# Access Compliance Report Public Rights-of-Way (Curb Ramps)

Main Street: HARVEST\_ST Cross Street: STONYBROOK\_DR Location: NE

ADA ID: RPAT211117122144 Ramp Type: Type 4 - Parallel Initial Pass/Fail: Pass Overall Compliance: No Severity Score: 0

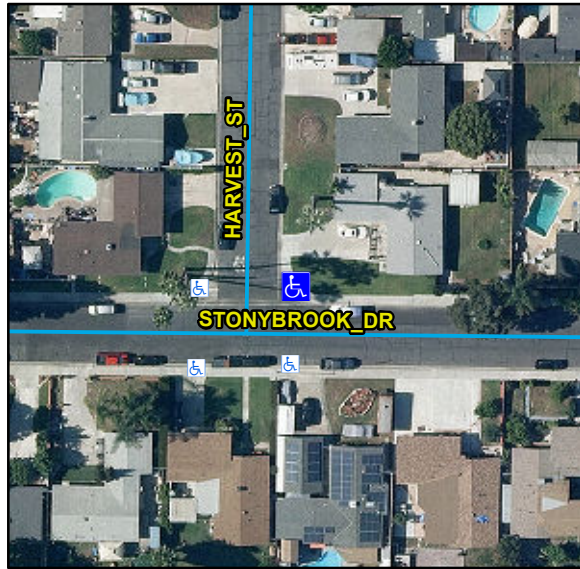
| Compliance | Description                   | Data       | Compliance | Description                   | Data   |
|------------|-------------------------------|------------|------------|-------------------------------|--------|
| No         | Gutter Cross Slope (%)        | 3.3        | Yes        | Perpendicular Joint Present   | Yes    |

Possible Solutions:

Remove & Replace Gutter.

R304.5.3, STD 1115
